APPLICATION FOR A NEW HOUSE

APPLICATION TO CONSTRUCT, ALTER OR REPAIR A SEWAGE DISPOSAL SYSTEM

NEW RESIDENCE FOR:
MICHELLE BLANK & FRED JACKSON
117 BEACHSIDE AVENUE WESTPORT, CT

SITE DEVELOPMENT PLAN

LOWER LEVEL FLOOR PLAN

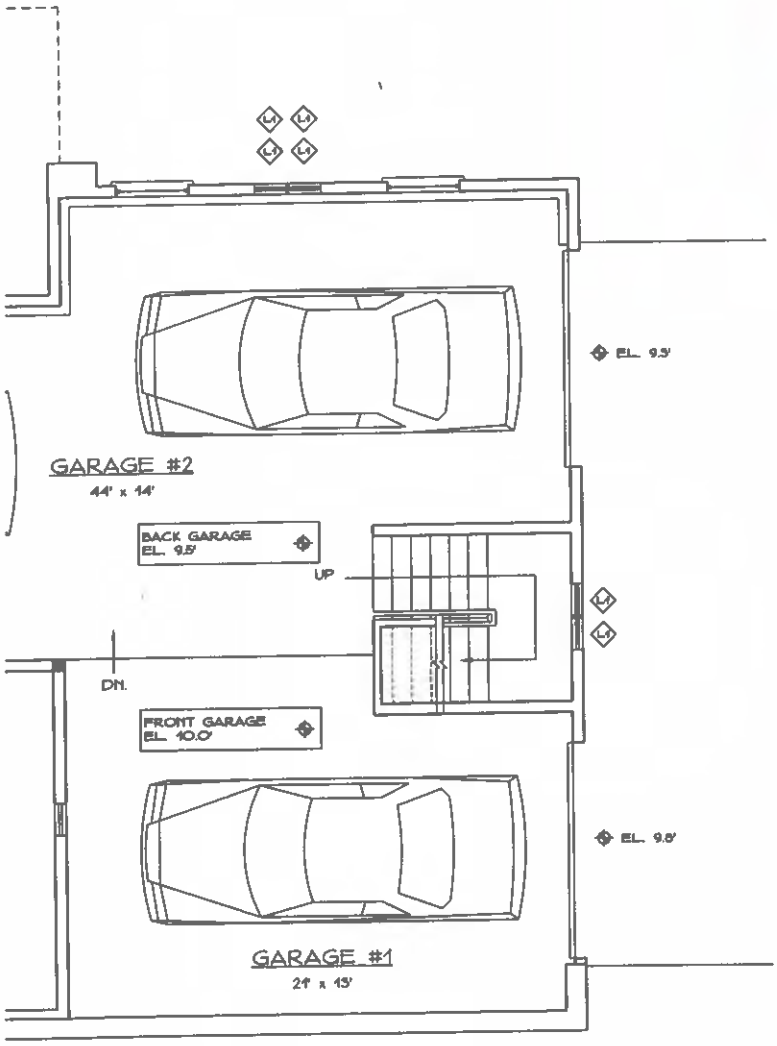
* 1 on first
3 on 2nd

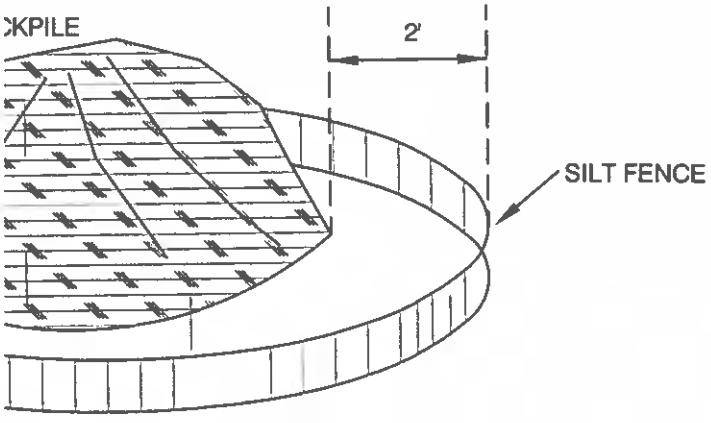
Conditions:
- Back fill disturbed areas w/ select fill to elevation 9.0' per PE plan.
- Install per PE plan dated 9/13/25.
- NO DRAINS w/in 50' down grade of system.
- See permit.
